June 18, 2021

Subject: Geologic Hazard Evaluation
Mayberry Development
aka Ellicott Town Center, Filings 1 through 4
Highway 94 and Log Road
Ellicott, Colorado
CTL|T Project No. CS18969-105

Geologic Map

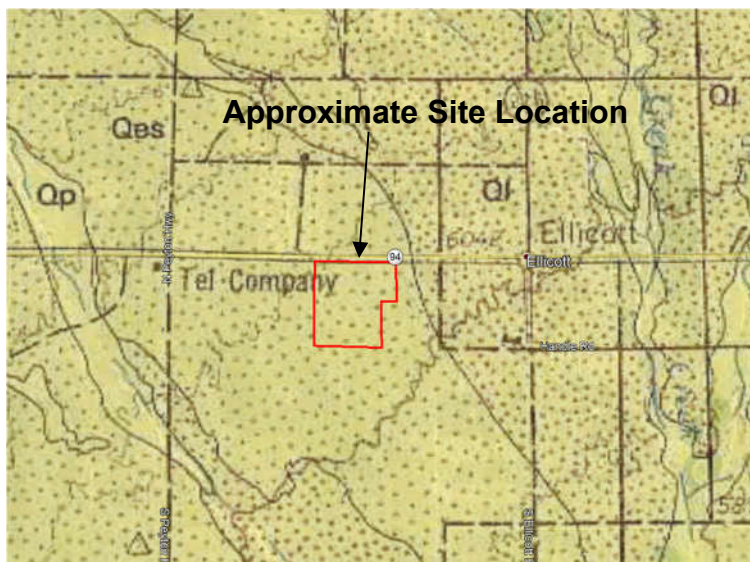
Please include a map depicting geologic hazards and constraints within the Filing 3 area.
